**CHARTER TOWNSHIP OF GARFIELD
PLANNING COMMISSION MEETING**

Wednesday, December 11, 2024 at 7:00 pm
Garfield Township Hall
3848 Veterans Drive
Traverse City, MI 49684
Ph: (231) 941-1620

A G E N D A

ELECTRICAL SITE PLAN

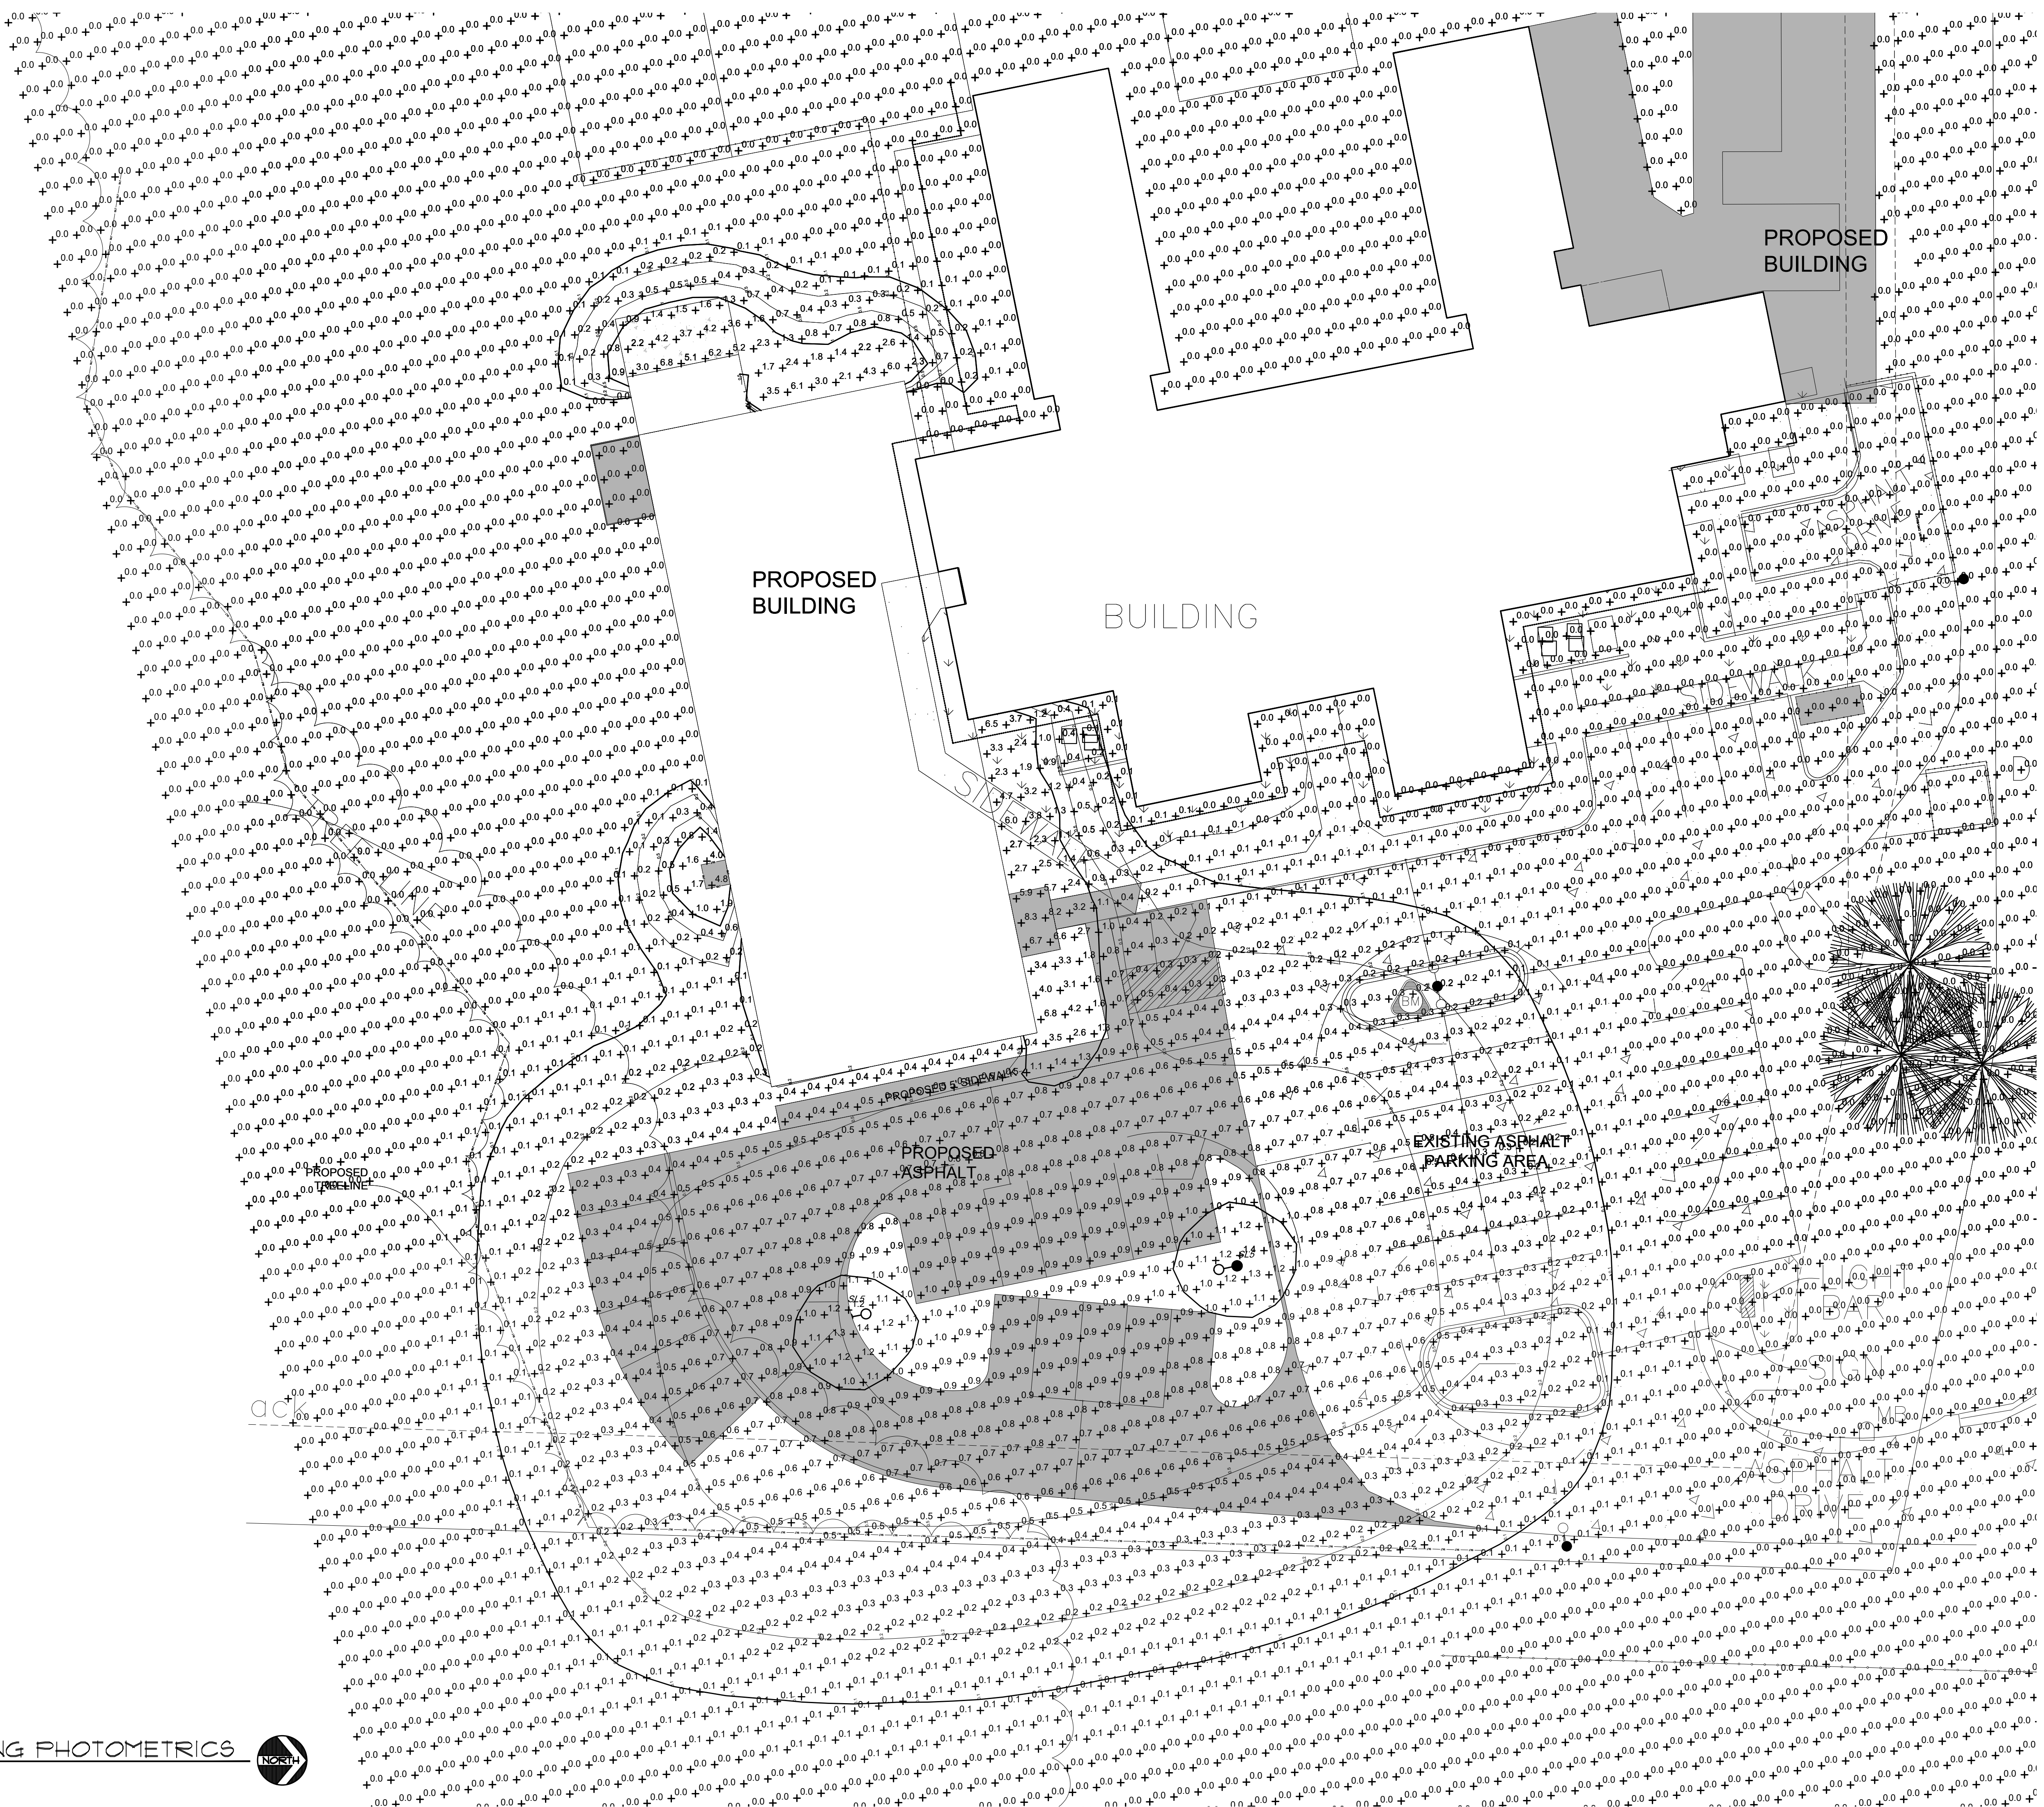
The site plan set includes an Electrical Site Plan (Sheet SE2.1) and Site Lighting Photometrics (Sheet SLC) to demonstrate site lighting. The applicant has also submitted a cut sheet of the proposed lighting fixtures. The lighting standards of Section 517 of the Zoning Ordinance are described by the following:

**EXISTING PARKING & PEDESTRIAN CIRCULATION PLAN
 CHERRYLAND CENTER COMPREHENSIVE DEVELOPMENT PLAN
 HOLIDAY PARK REALTY**

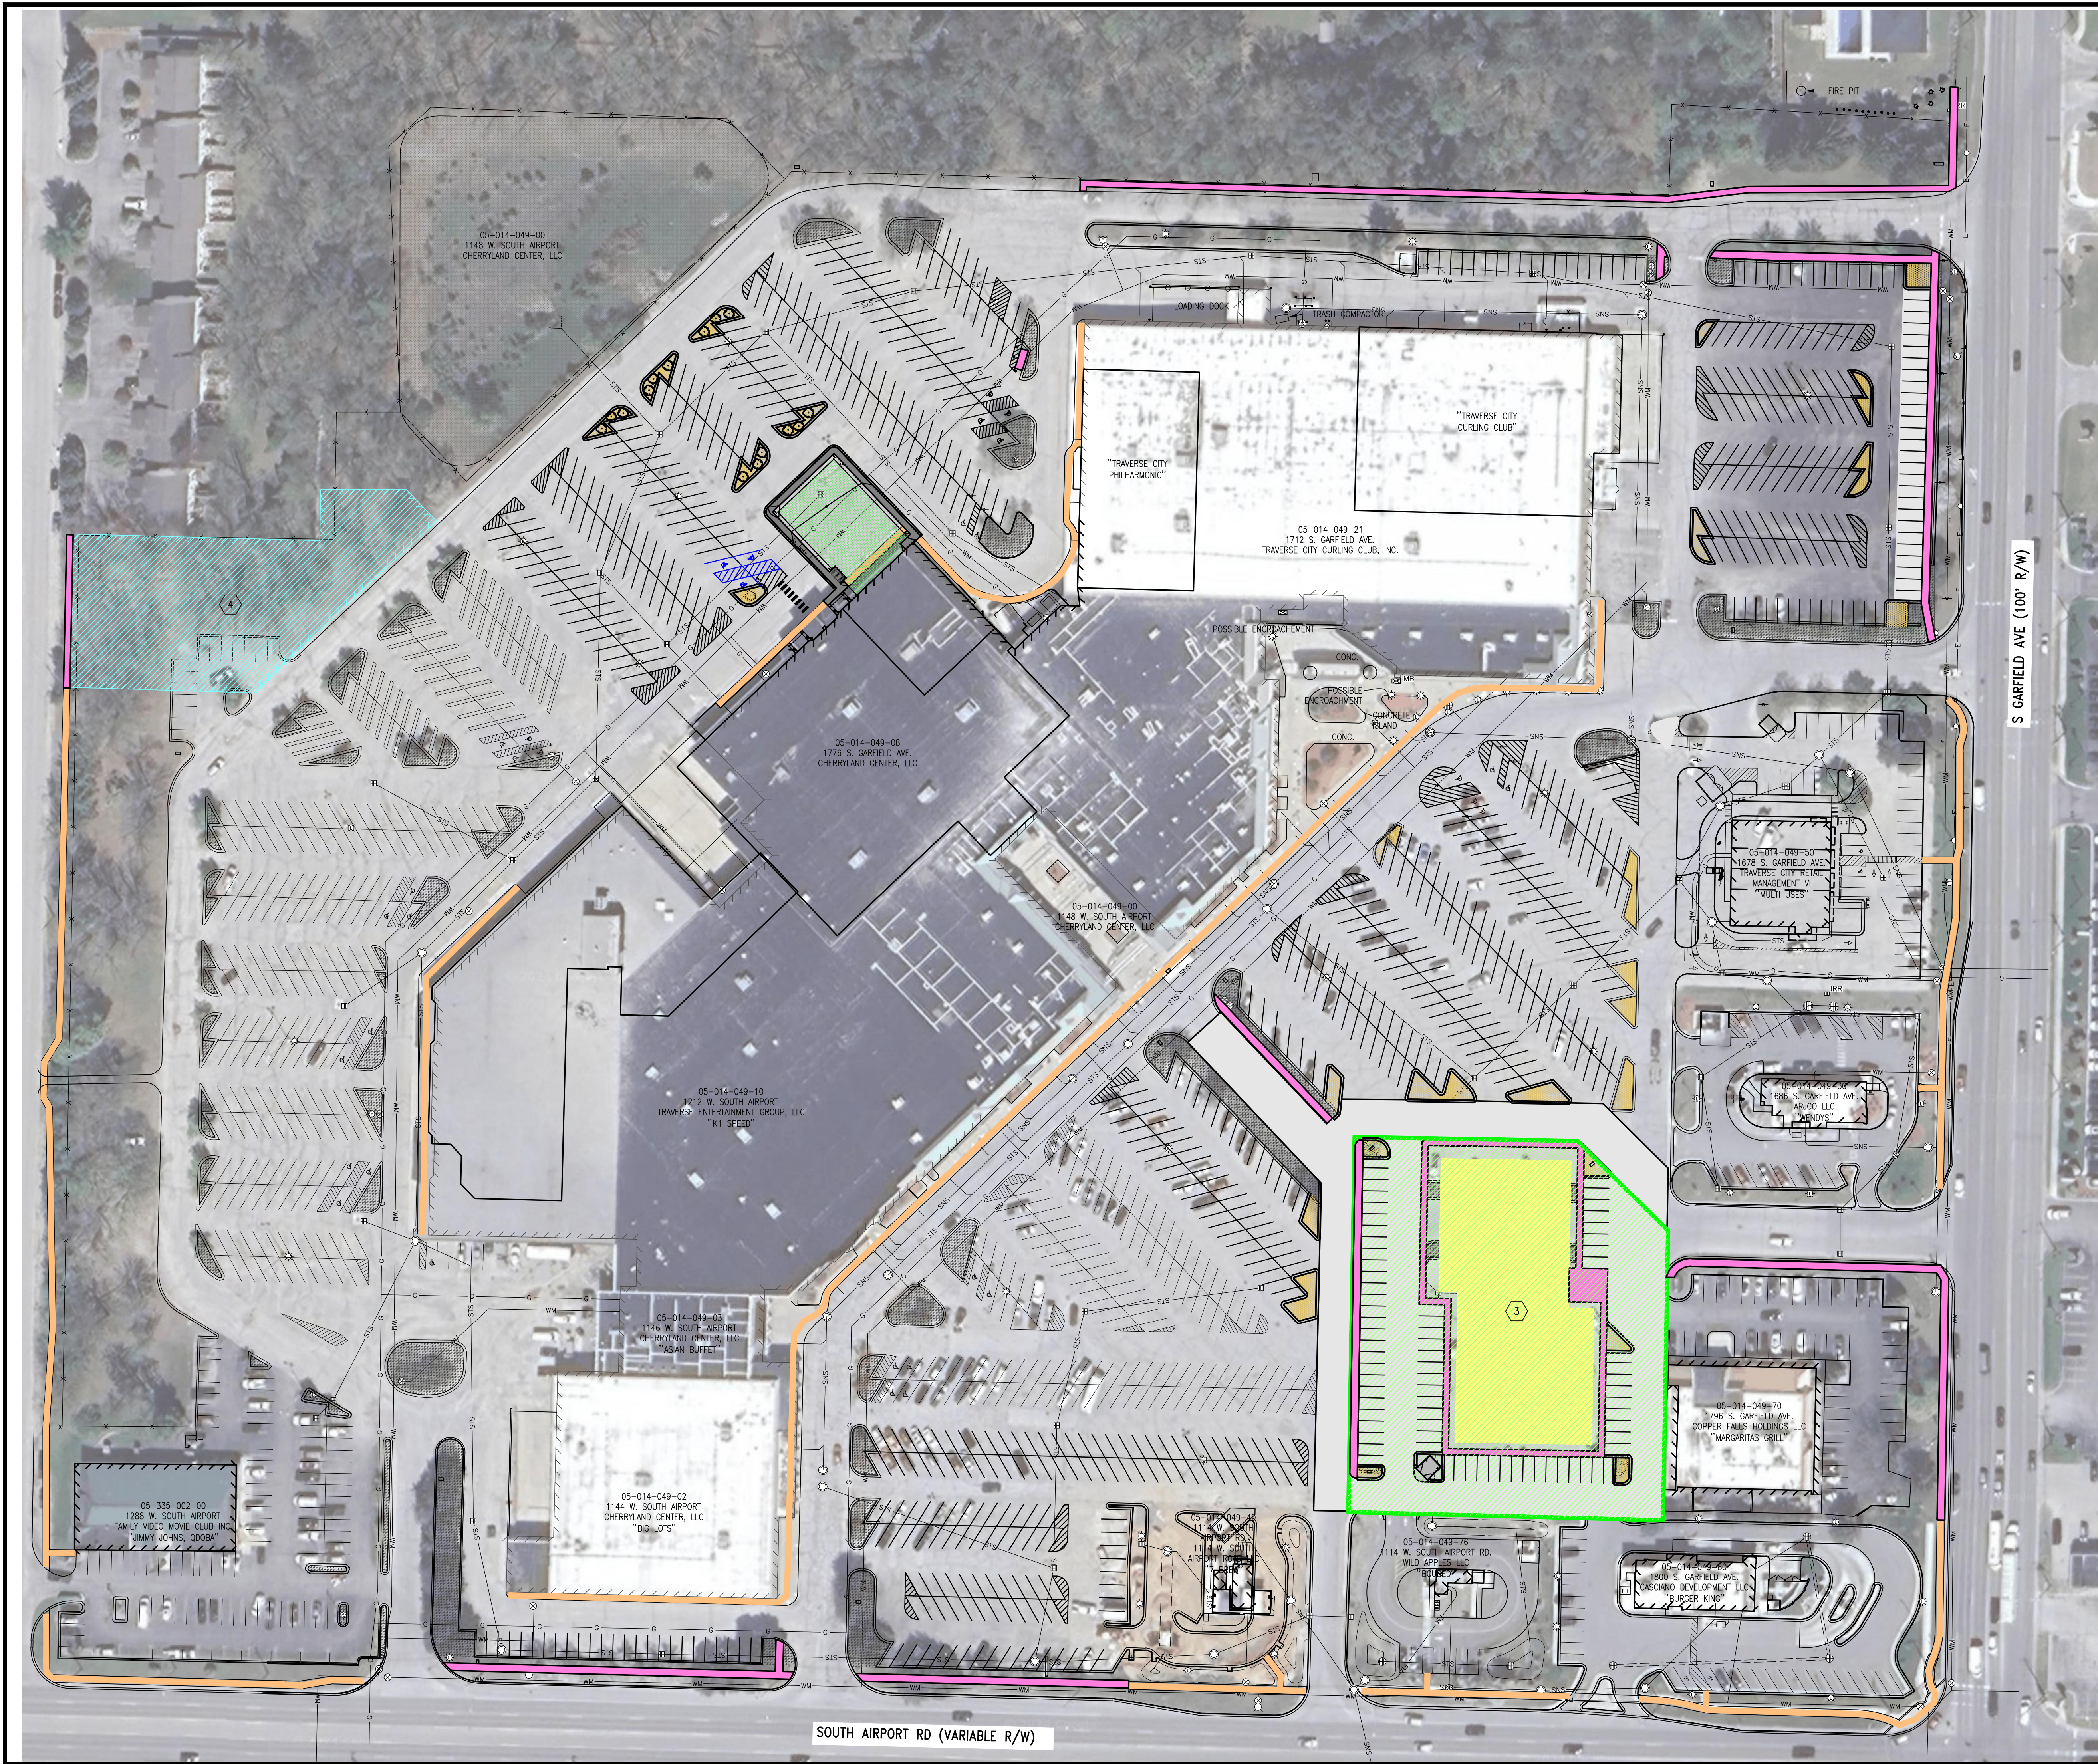
To determine parking for the site, a compilation of all the current uses and expected uses has been completed. See Sheet 3 in the comprehensive development plan. The existing 2024 parking count for the center is 1,480 spaces. This count excludes the outlot parcels which provide their own parking, including 7Brew, Biggby, Burger King, Margaritas Grill, Wendy’s, and Starbucks. There are three approaches provided to determine the parking demand for the entire center:

- 1) Existing Parking Landscape Islands. Sheet 3 on the comprehensive development plan includes an existing parking landscape island inventory. The inventory states there are 37,800 square feet of parking landscape islands or approximately 0.86 acres.
- 2) Vegetative Transition Strip. In addition to the parking landscape islands, there is the vegetative transition strip as required by Section 322.D(6) at the north and west sides of the site containing approximately 503,473 square feet or 11.5 acres of greenspace (not including the retention basin). With the retention basin, there are 544,992 square feet or 12.5 acres of green space.
- 3) Fronts of Buildings. There is existing landscaping along the fronts of the buildings.
- 4) Buffers. The required buffers are in place along the County roads.

Sheet 3 of the comprehensive development plan provides a pedestrian circulation plan. Future changes, including additional sidewalks, will be required based on new use and building proposals.
